**THE SHOPPES AT AVALON PAD**  
**RESPONSES TO QUESTIONS AND OTHER**  
**RELATED INFORMATION**  
**TOWN OF GLASTONBURY**  
**JUNE 22, 2010**

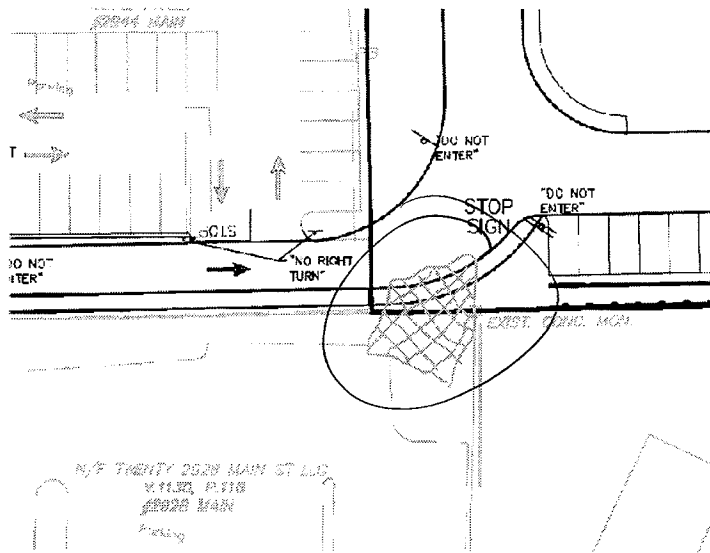
**Question: Can a parking lots between *The Shoppes at Avalon* and the office building at 2928 Main Street be linked to provide internal off-street connections?**

The Developer would welcome the creation of a link between the parking areas of *The Shoppes at Avalon* and 2928 Main Street providing that developing such a link does not delay the approval process.

A natural location for the link, which is acceptable to the developer, is presented below.

*Site Plan entitled, 'Brewster Condominiums – Landscape Improvement Plan'*

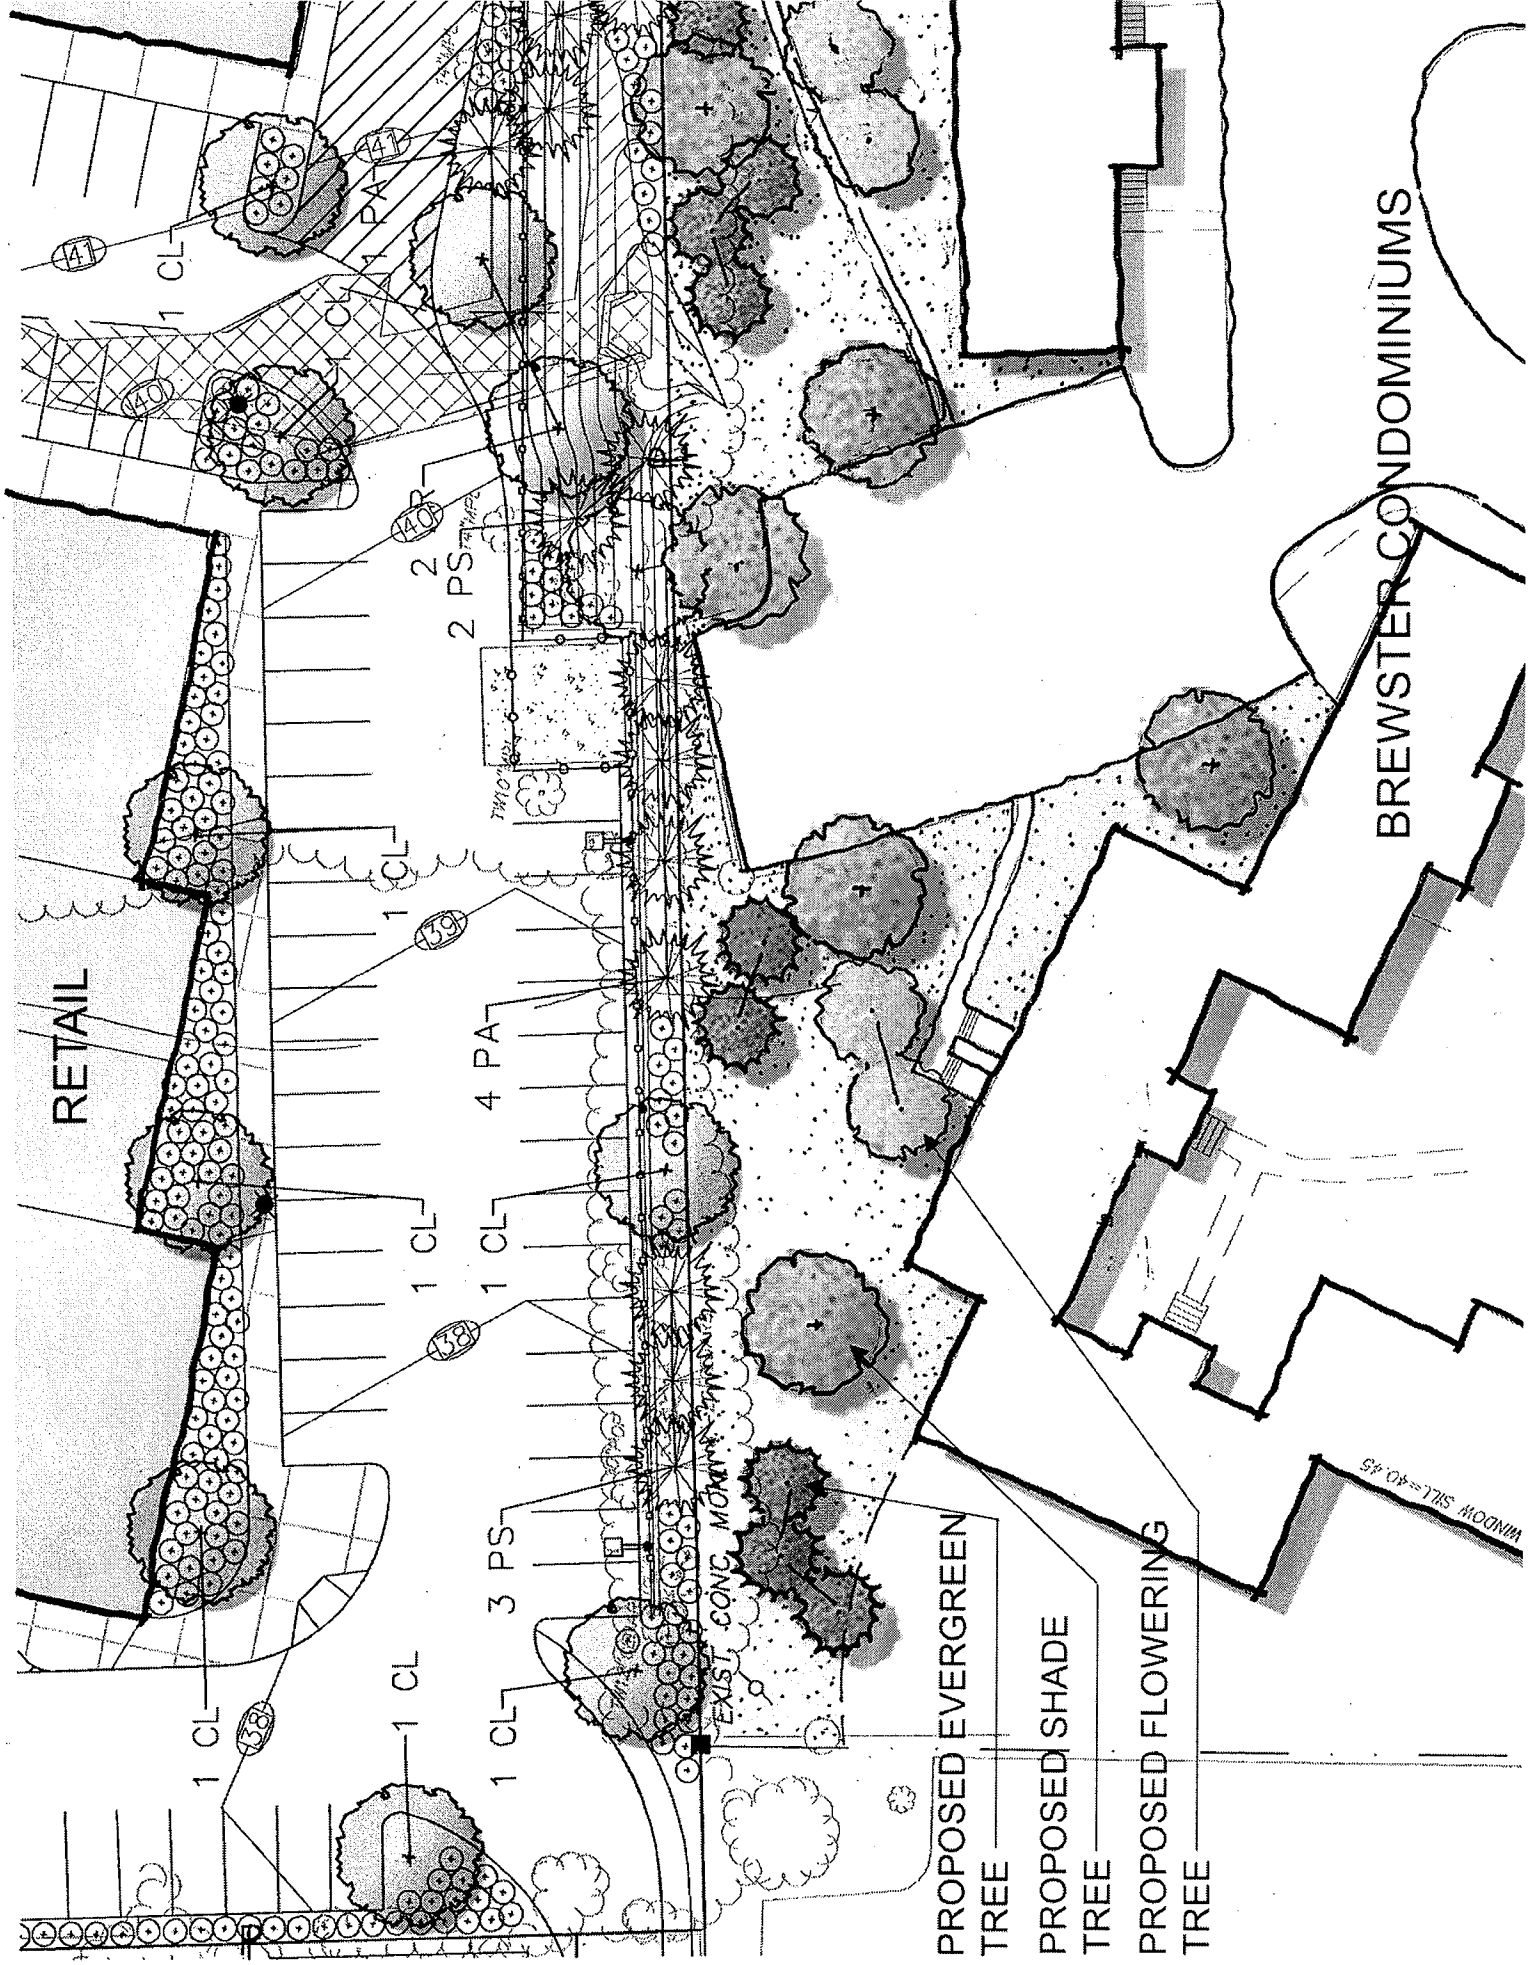
Accompanying this memo, please reference the attached site plan depicting additional landscaping proposed for the Brewster Condominium Development adjacent to the proposed Shoppes at Avalon.

As a condition of approval, Avalon would undertake this additional landscaping at its own cost on the Brewster property if it is the desire of the Brewster owners.
